ENGINEERING CHANGE NOTICE
DART AEROSPACE LTD

Date: 08.03.31	Job No.: 00056	ADR Yes/No: Y	ADR Date: 08.03.31	ECN #: 1164
Product No.: D350-591		Created By: <i>LL</i>	Approved By: <i>MW</i>	
Product Name: Heli-Access-Step		Checked By:		General Manager Approval:

DART SERVICE INSTRUCTION

TO AMEND DRAWING D350-591 REV. F

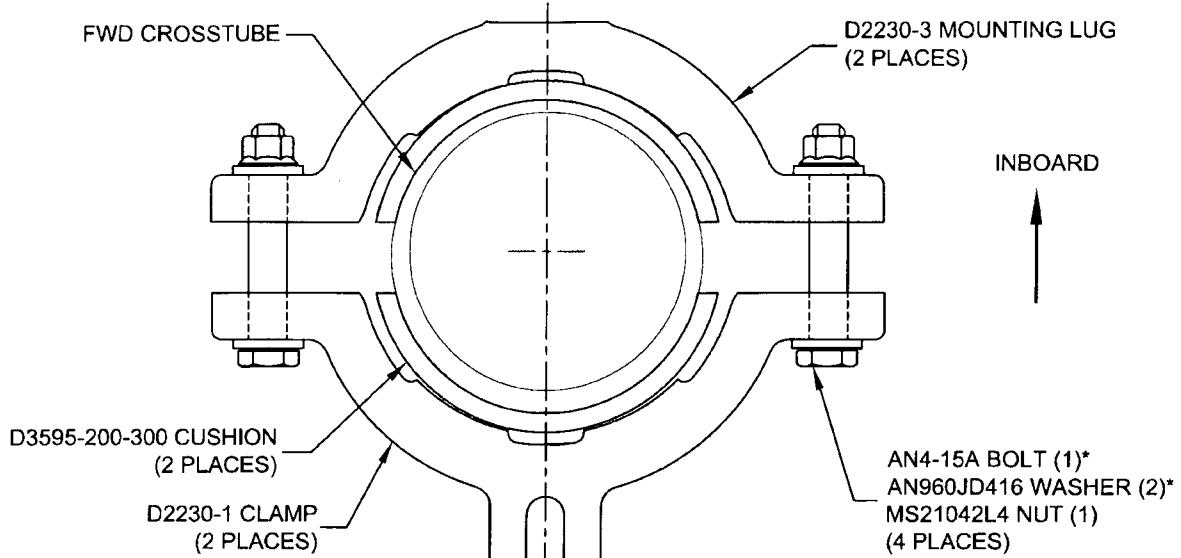
FOR CUSTOMERS WITH EARLY MODEL D350-591-311/-312 STEPS*, THE DSI 9410-011 STEP MODIFICATION KIT IS AVAILABLE

QTY -011	PART NUMBER	DESCRIPTION
X	DSI 9410-011	STEP MODIFICATION KIT
4	D2732-030	CUSHION
2	D3595-200-300	CUSHION
8	AN4-15A	BOLT
16	AN960JD416	WASHER
8	MS21042L4	NUT (OR MS21042-4)

FIGURE 1 - CLAMP/CUSHION INSTALLATION

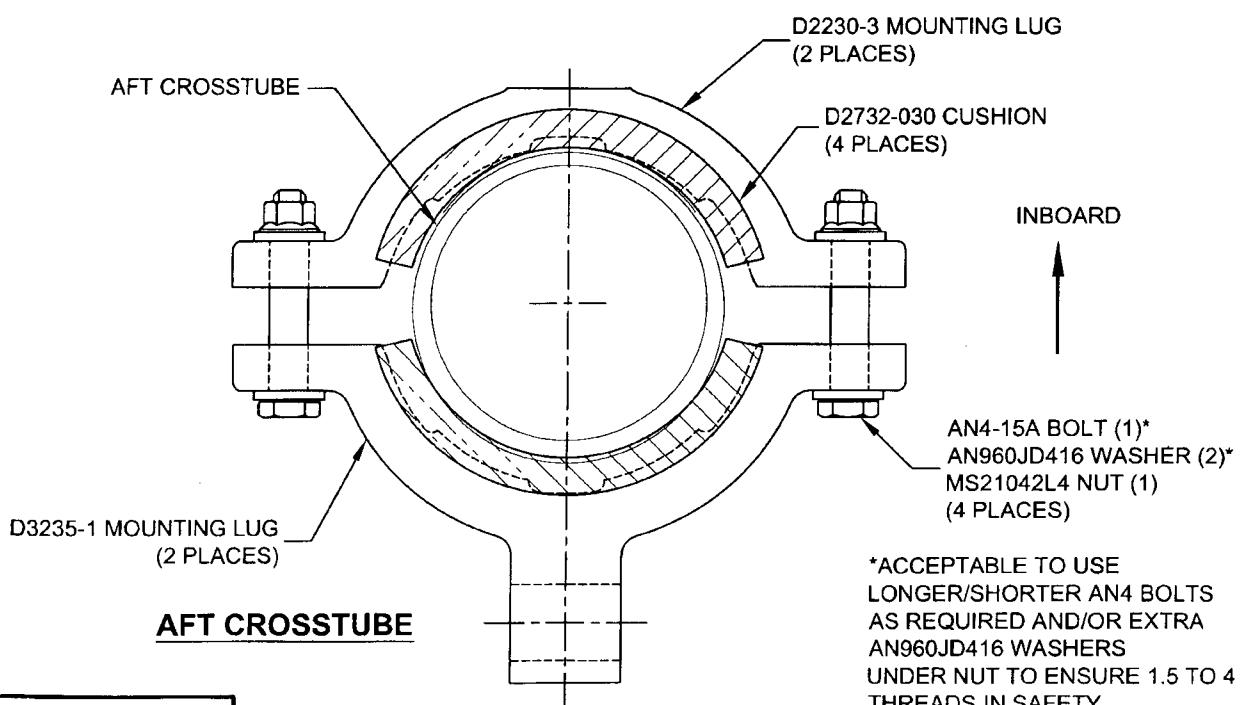
TO IMPROVE THE FIT OF THE D350-591-311/-312 STEPS, INSTALL THE D2732-030 CUSHION (AFT CROSSTUBE) AND D3595-200-300 CUSHION (FWD CROSSTUBE) AS SHOWN IN FIGURE 1 IN PLACE OF THE D2856-400-720 ABRASION CALLED OUT ON DRAWING D350-591 REV. F.

*REMOVE THE INSTALLED D2856-400-720 ABRASION STRIPS
IN ACCORDANCE WITH ICA-D350-591.

*ACCEPTABLE TO USE
LONGER/SHORTER AN4 BOLTS
AS REQUIRED AND/OR EXTRA
AN960JD416 WASHERS
UNDER NUT TO ENSURE 1.5 TO 4
THREADS IN SAFETY
